EPA Comments

SUBJECT: Comments on "DRAFT REPORT - Dam Safety Assessment of CCW Impoundments: TVA Cumberland Fossil Plant"

Re: Response to Recommendations
USEPA CCR Impoundment Assessment DRAFT Report
Cumberland Fossil Plant (CUF)
Cumberland City, Tennessee

File Name: Section Q.gsz

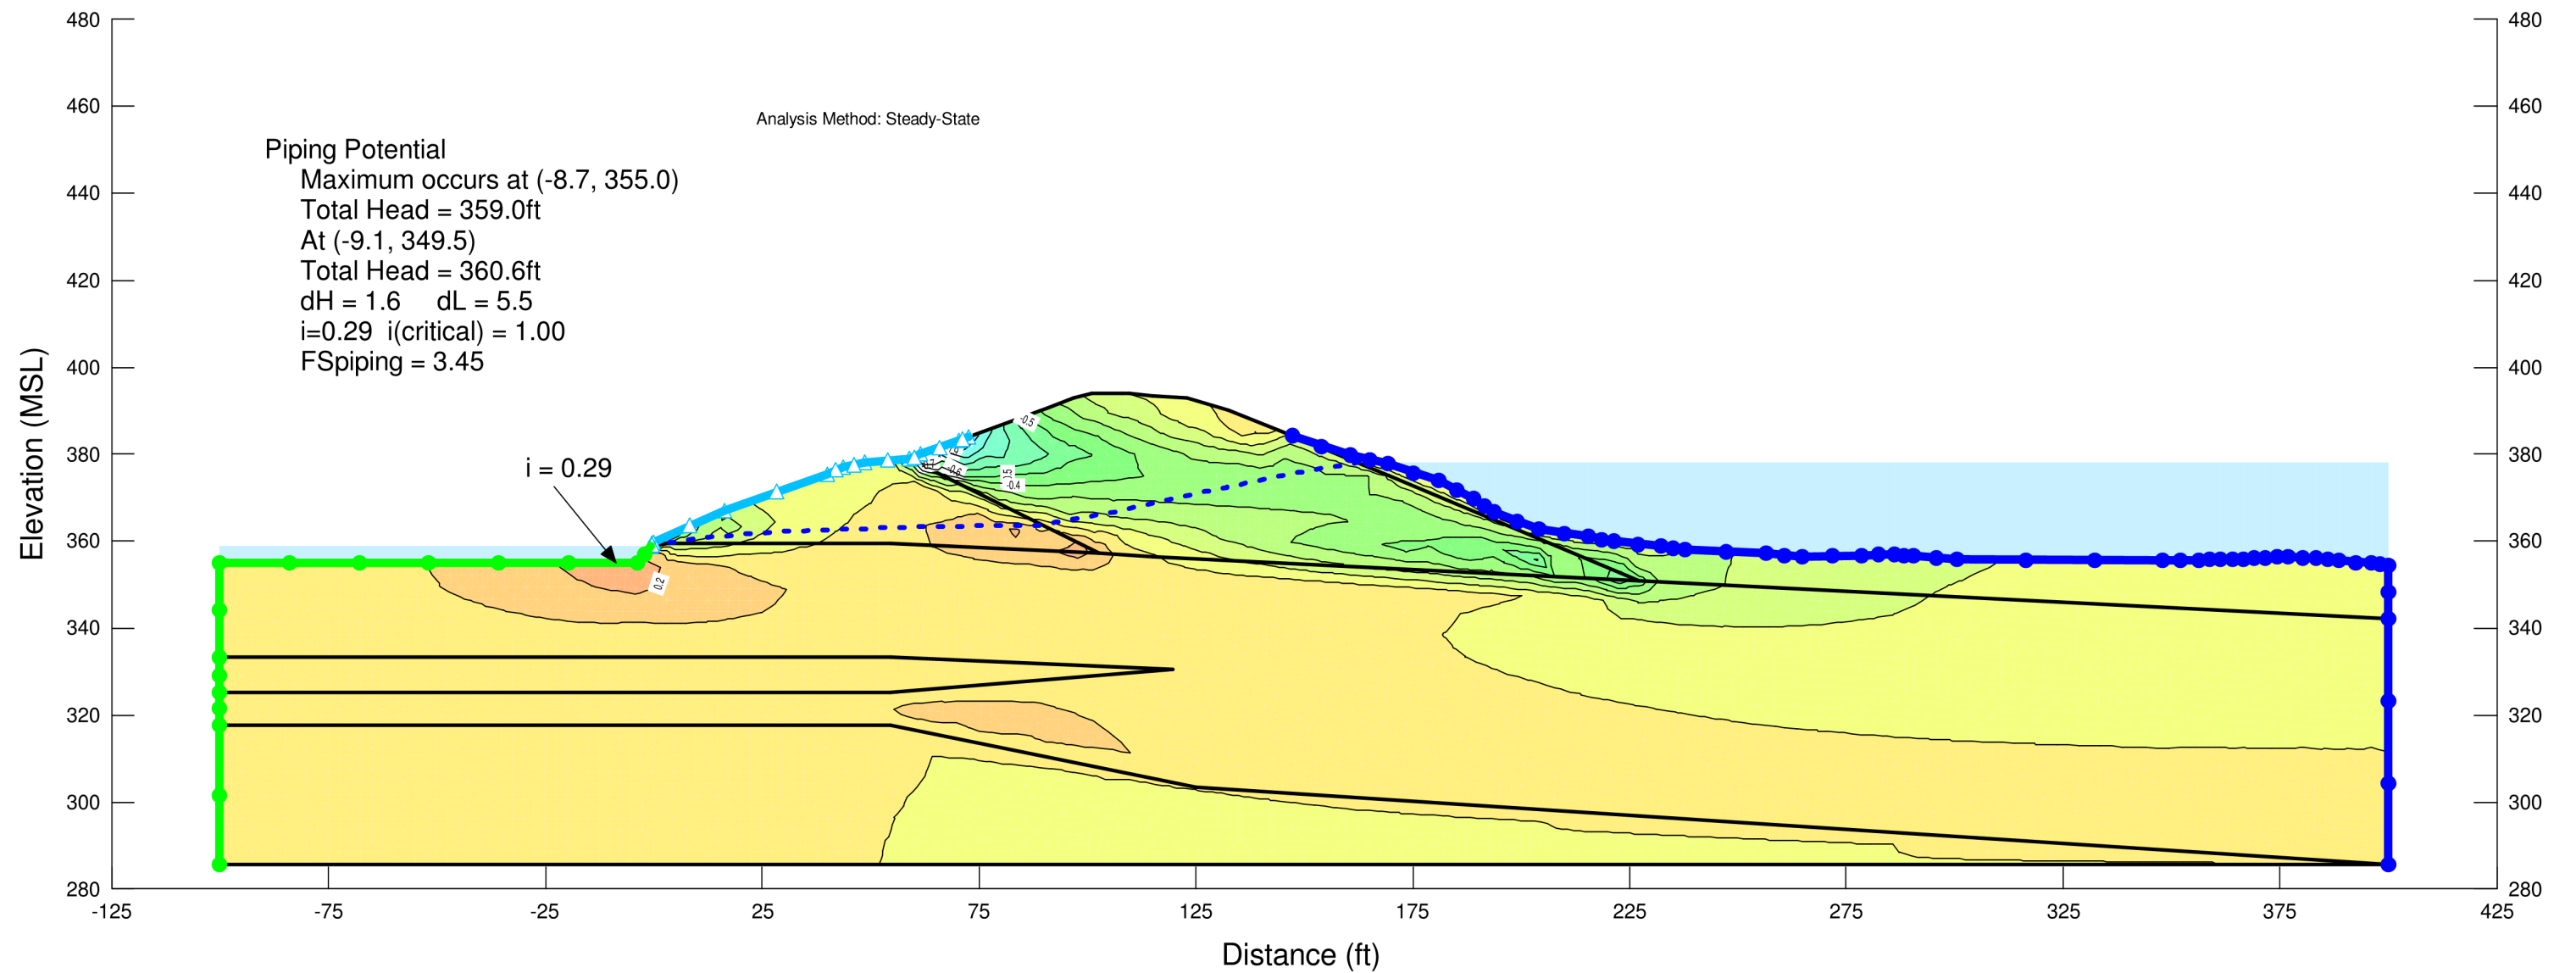
Dewberry Report Section 1.2.1 1) – Ash Pond: Install Stantec's recommended remedial measures for increasing the factor of safety against piping failure to the acceptable margin. If the driven sheet-pile wall is selected as the remedial measure, close attention should be paid to sheet-wall alignment location and depth to achieve maximum benefit in lengthening the seepage path to reduce exit gradients; the sheet-wall alignment should generally be at or upstream of the centerline of the dike crest.

Stantec Response: Since the time of Dewberry's assessment, the operating pool level for this pond has been lowered from El. 384.2 to El. 378.0 (6.2 feet). Stantec has revised the seepage analysis for Sections P, Q and R based on the lowered pool level and recent piezometer data. Piping factors of safety (FS) have increased to 3.5, 3.5 and 4.0 for Sections P, Q and R, respectively (see attached results). Piping FS's for these sections are now satisfactory because they are greater than the Cedergren FS criterion of 2.5 to 3 (that is

File Name: Section H (StabRepDgn)revised.gsz
Analysis Name: Steady-State Seepage
Date Saved: 10/12/2012
Last Solved on 10/12/2012 at 11:06:02 AM
Analysis Method: Steady-State

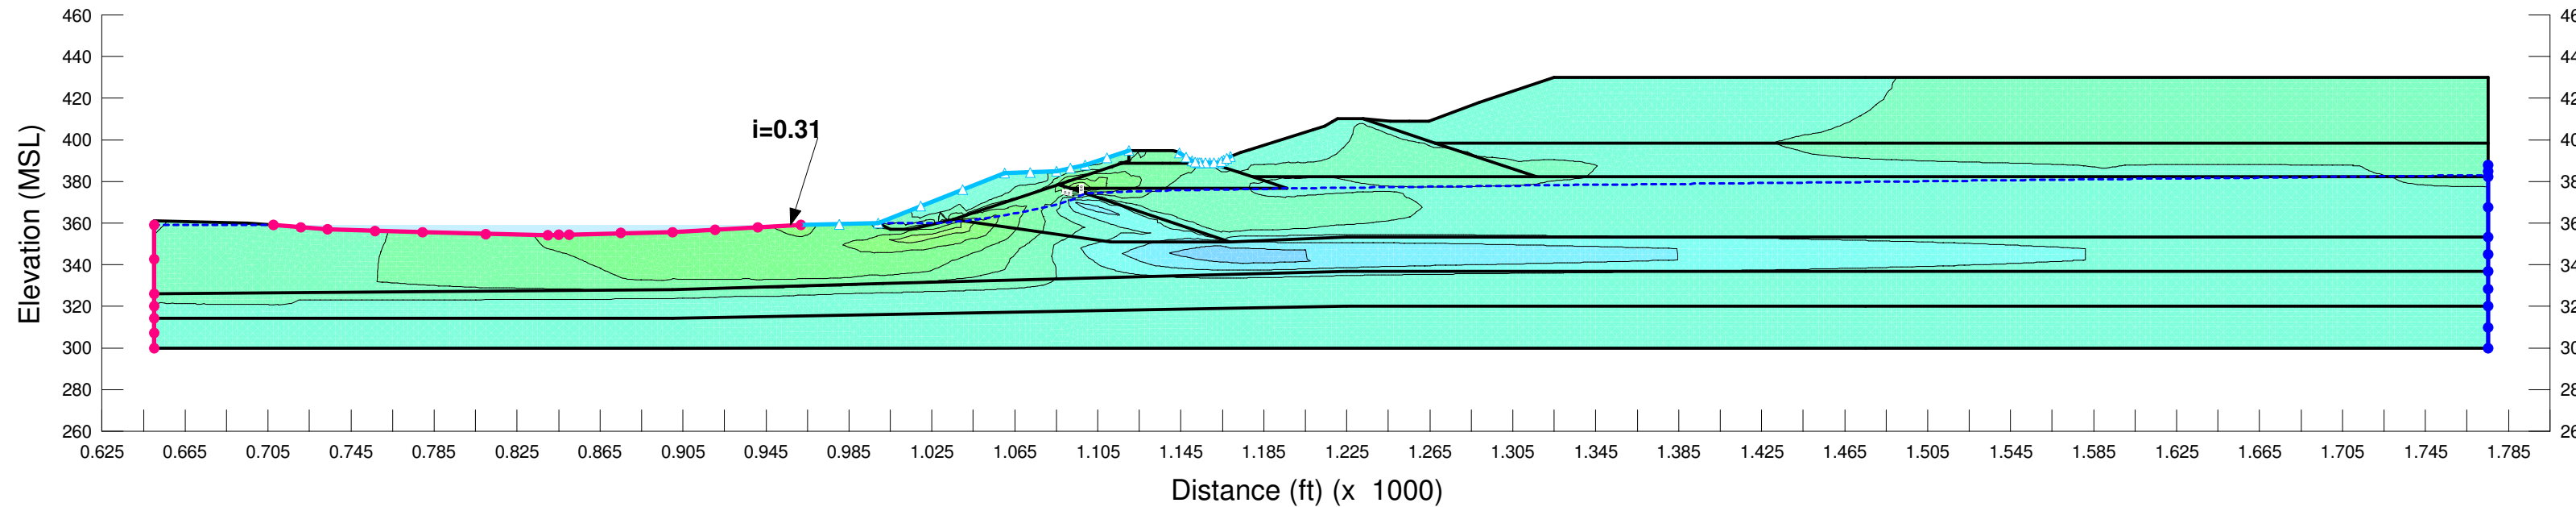
Dewberry Report Section 1.2.1 2) – Gypsum Disposal Area: *Install the planned lined ponds in the Gypsum Disposal Area as soon as possible for receiving and settling the gypsum slurry that must be sluiced to the Gypsum Disposal Area whenever the dewatering facility has an outage. Reevaluate the piping potential factor of safety after the lined ponds have been in place for about a year, to check whether or not the elimination of sluice water in the gypsum stack reduces the seepage exit gradients sufficiently to result in acceptable factors of safety against piping. Closely monitor the seepage conditions at the critical section in the interim. If the seepage exit gradients have not sufficiently abated, develop and implement a remedial measure to lower the exit gradients and achieve acceptable factor of safety against piping failure.*

Stantec Response: The FML-Lined Gypsum Settling Channels project is currently under construction and is scheduled for completion in April 2013. Sluicing to the stack has been discontinued and has not occurred for about 3 years. Since sluicing has stopped, piezometer levels in the gypsum have lowered. Stantec has revised the seepage analysis for Section H and the current piping FS is 3.1 (see attached results) which is satisfactory. TVA will continue to collect piezometer data and ensure that an acceptable factor of safety against piping is maintained.

Acceleration versus depth profile at Boring CUF-H-2B (CUF Gypsum Stack, Section H).
Results are derived from one-dimensional ground response analysis.

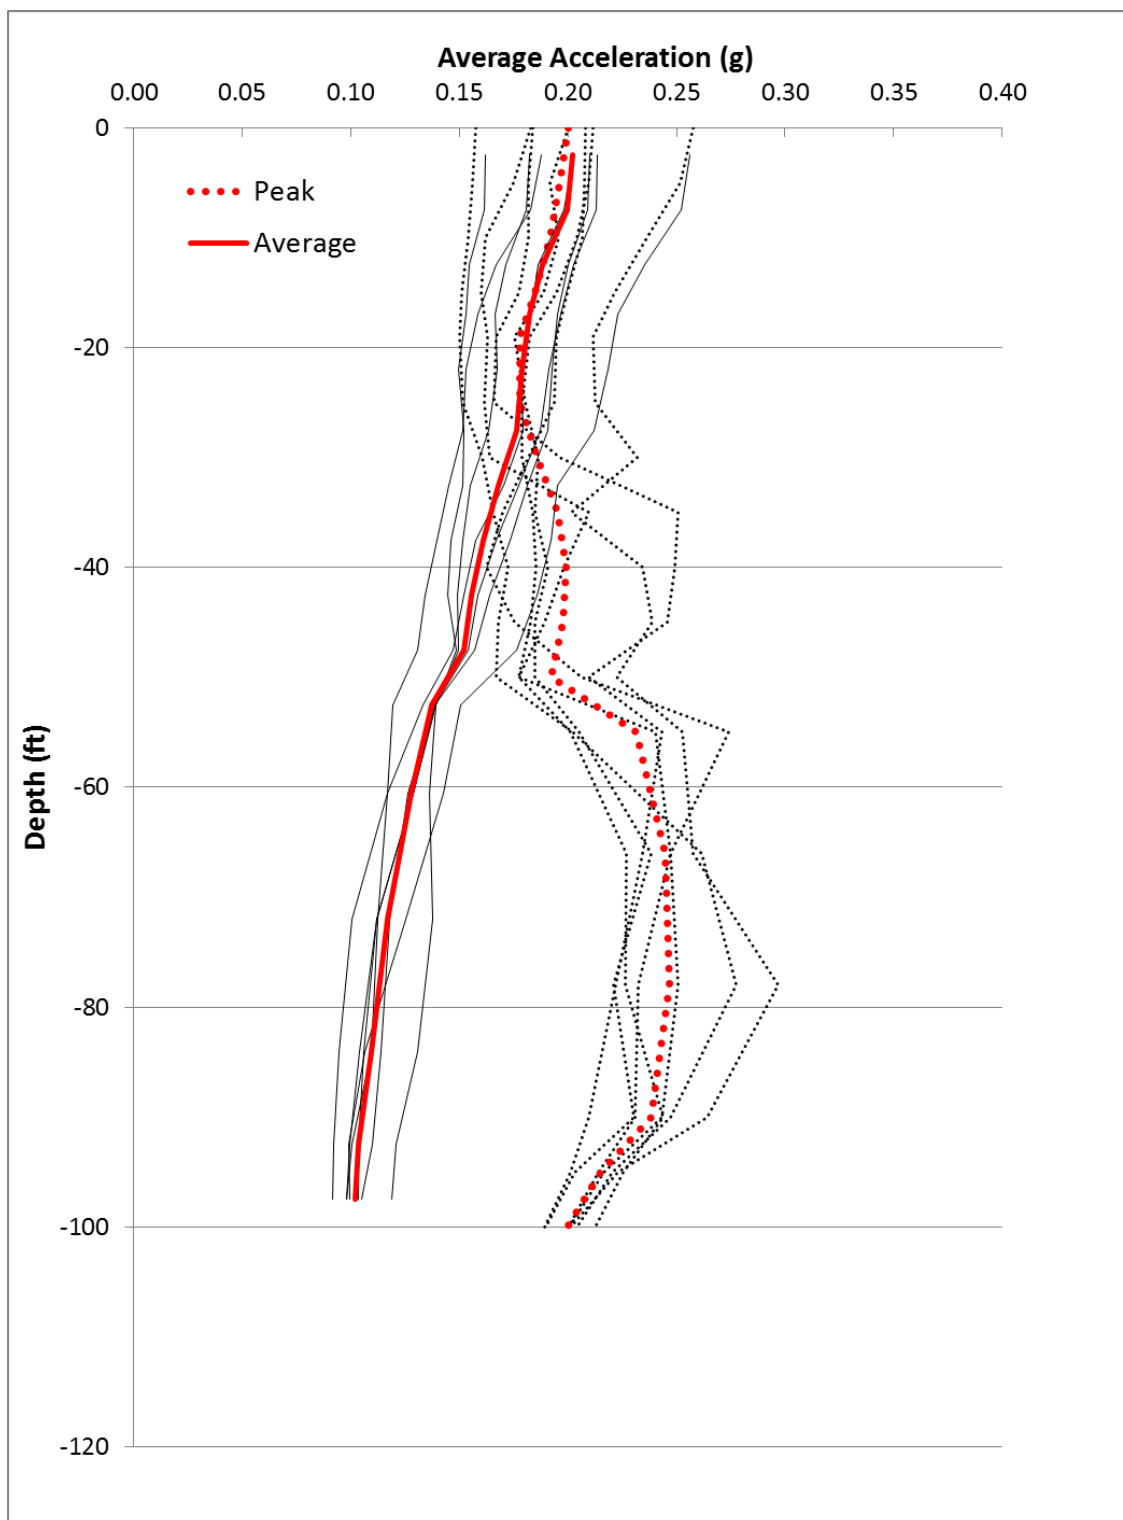
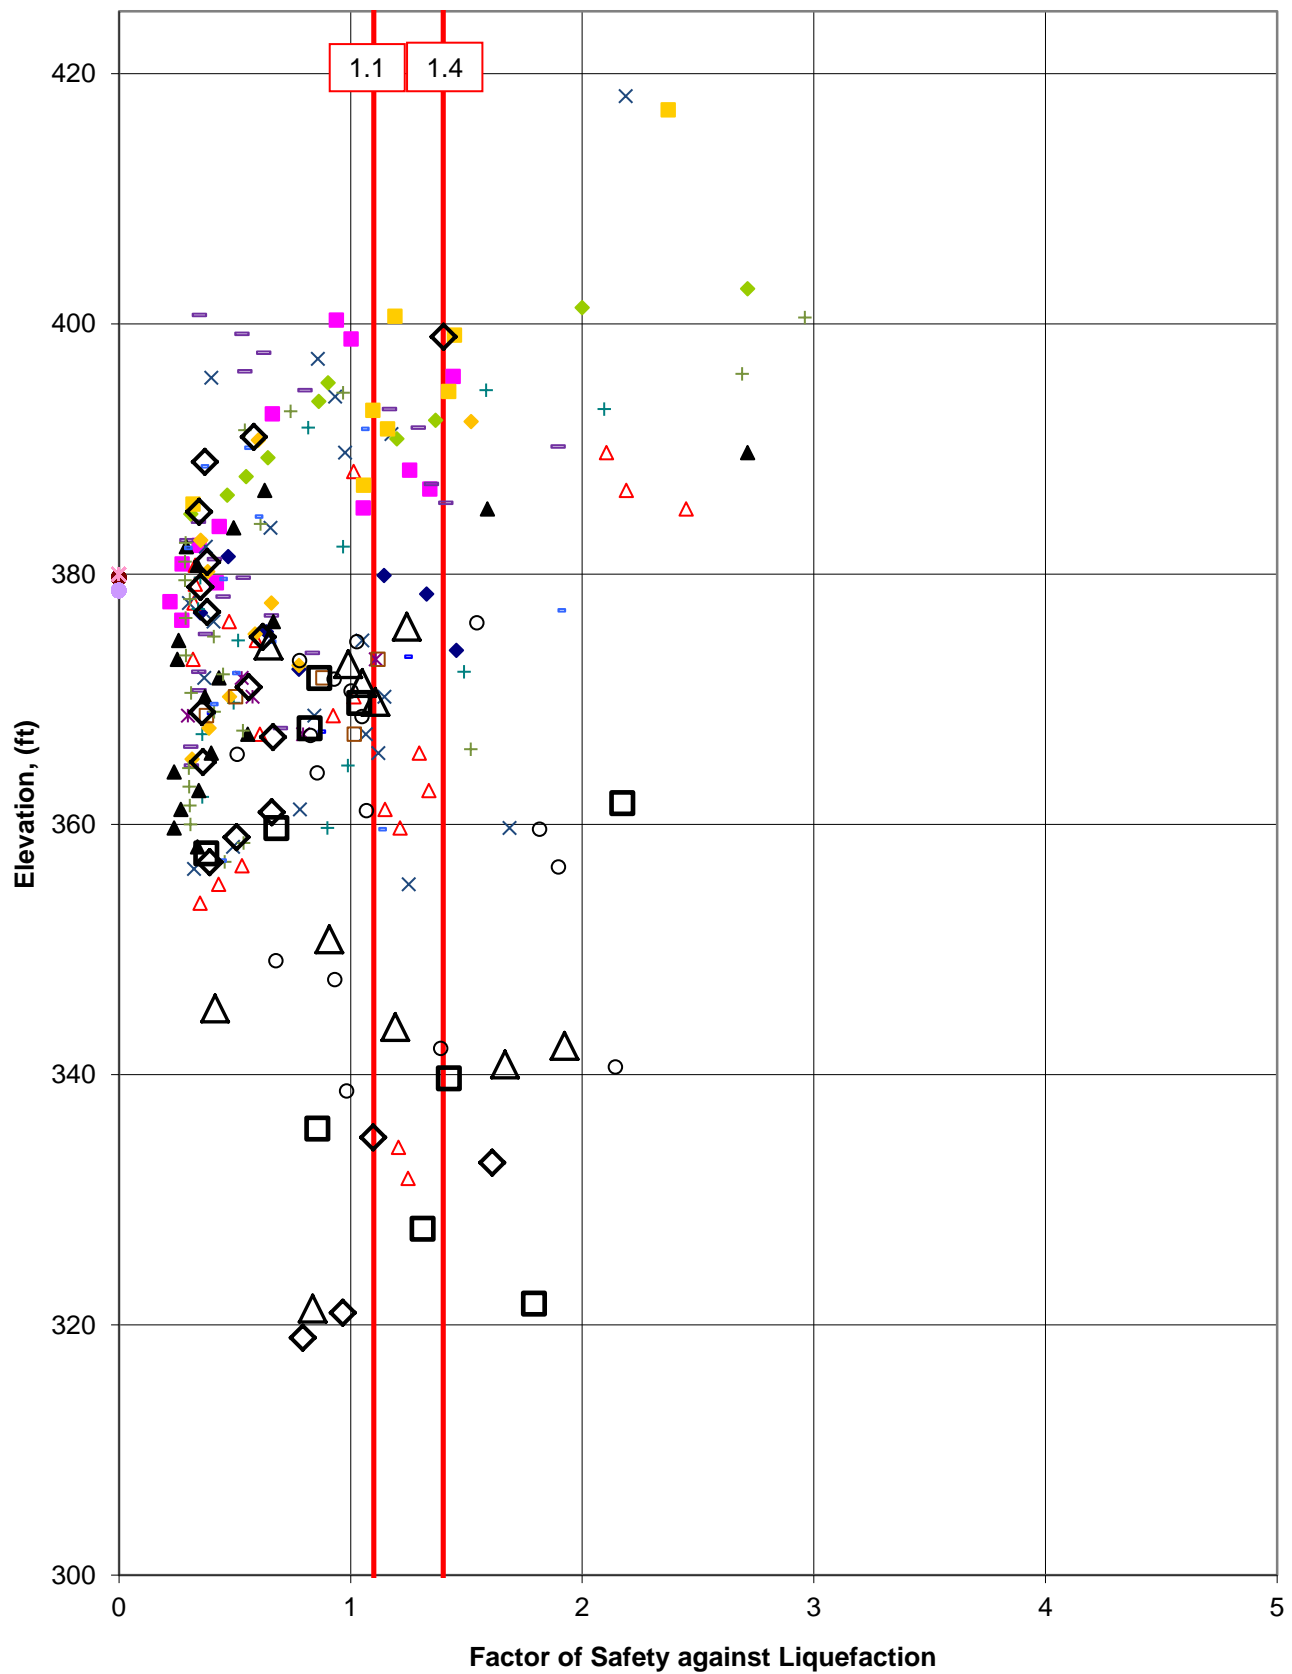
Dewberry Report Section 1.2.3 1) – Gypsum Disposal Area: *Perform a quantitative liquefaction analysis of embankment sections overlying very loose/ loose saturated fly ash at the Dry Fly Ash Stack and the Gypsum Disposal Area; evaluate the impact of liquefaction on the containment dikes, if liquefaction is indicated; and evaluate the consequences of liquefaction failure of the containment dikes.*

Stantec Response: Stantec performed a liquefaction potential assessment based on ground motion estimates for the 2,500-year earthquake scenarios, Standard Penetration Test borings, and corresponding laboratory test results. A description of the methodology and the results (ground response analysis and factor of safety against liquefaction versus elevation) are attached. Consistent with previously submitted seismic stability analyses, Section H was analyzed for the Gypsum Disposal Area. The saturated ash materials are anticipated to undergo liquefaction for the 2,500-year earthquake.

Section H - Gypsum Stack
Cumberland Fossil Plant
Cumberland City, Tennessee

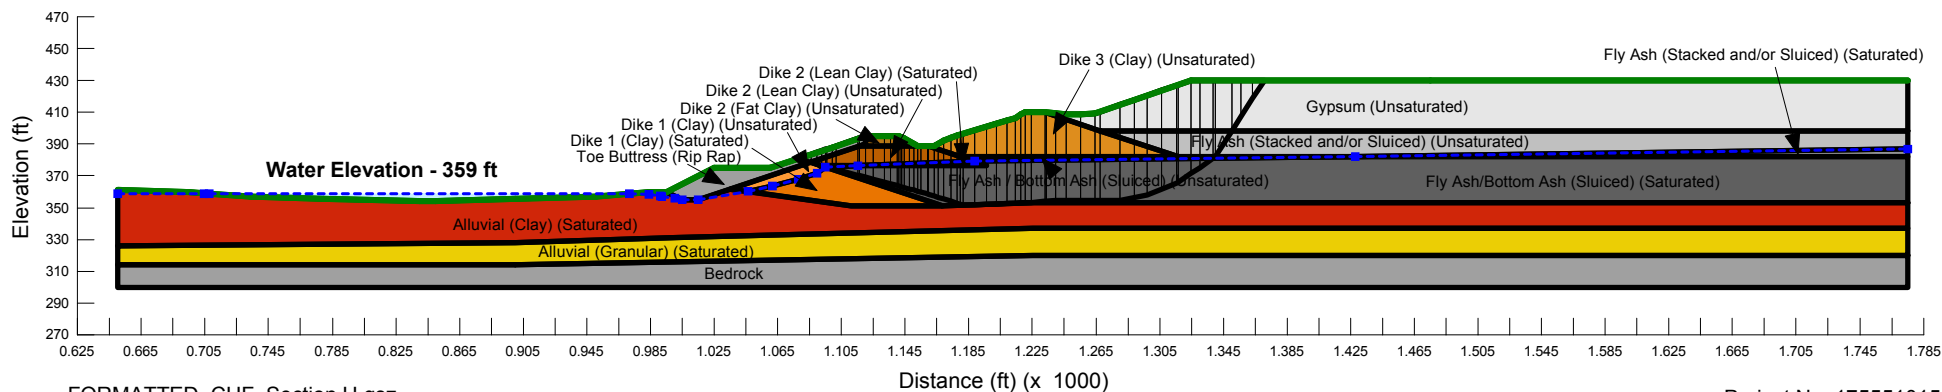
Dewberry Report Section 1.2.3 3) – Gypsum Disposal Area: *Review the basis and reasoning for the "design" seismic coefficient used in the pseudostatic slope stability analysis, rerun the analysis if a modification appears appropriate, or perform a higher level of analysis that uses more sophisticated methods. (Note: If a deformation analysis is done, there may be no need for the pseudostatic analysis. However, a post-earthquake static slope stability analysis using reduced shear strengths would be appropriate.)*

Stantec Response: A higher level of analysis that uses more sophisticated methods was performed for Gypsum Disposal Area Section H. A description of the methodology and the results (slope stability cross sections, including table of material parameters) are attached. The results indicate that Section H has a factor of safety of 1.1 for post-earthquake stability using reduced shear strengths, which is satisfactory.

Factor of Safety: 1.1
